# New Product Release

07/05

## Ford just flipped its lid . . . inner lid, that is.

Recessed Plastic Inner Lid  
W3BPD

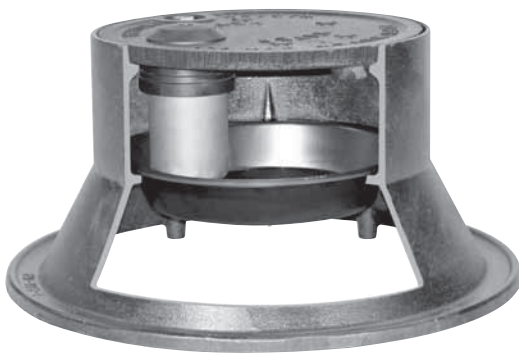
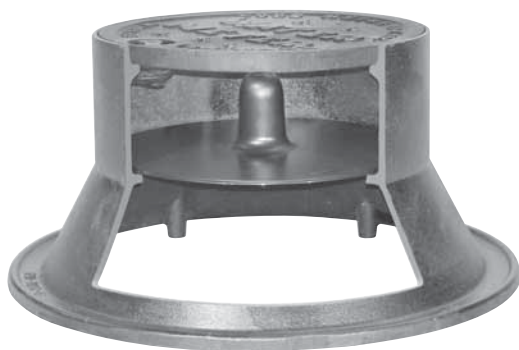
Ford's Wabash Double Lid Covers having a 11-1/2" lid size, with an E-read option, will now have the W3BPD recessed inner lid as the standard inner lid at *no additional charge*. The 2" recessed plastic inner lid provides frost protection and allows up to six inches of space for installation of a transmitting device. This change only affects the W3, W4, W31, W32 and W3H covers with the E-read option.

Wabash covers with 11-1/2" lid size without the E-read option will continue to have the W3BP flat style, inner lid. To order covers with the W3BPD recessed plastic inner lid option, without the E-read option add "-D" to the catalog number. Example: W3-D
